Leak TL/10 alternative output stage.

Leak TL/10 component layout for alternative output stage.

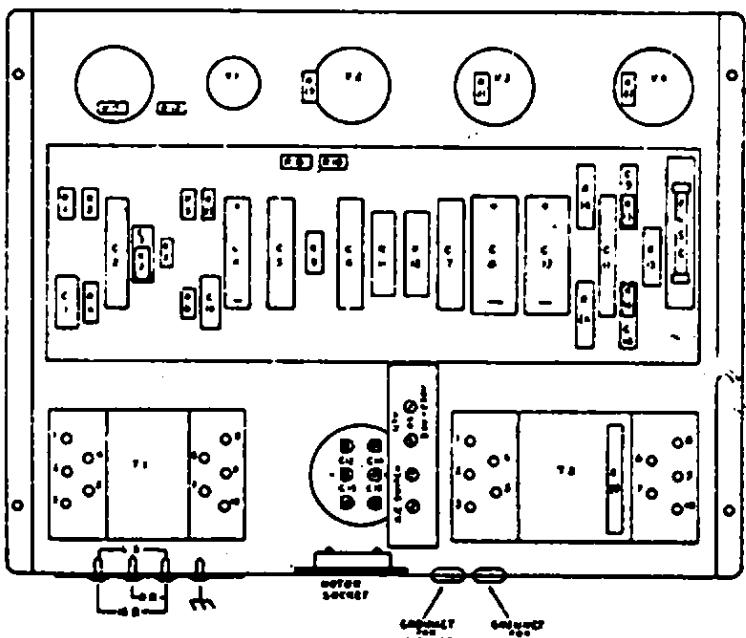
NOTE: Brimar 6AG6G is an exact equivalent for the KT61.
6L6 valves may be used instead of the KT61,
provided the following modifications are made:

R3 changed from 470k to 1M
R5 changed from 100k to 330k
R14 changed from 100 Ohms to 300 Ohms, 3 Watt
C8 to be omitted (these mods refer to the o/p stage
with single cathode resistor for two valves)
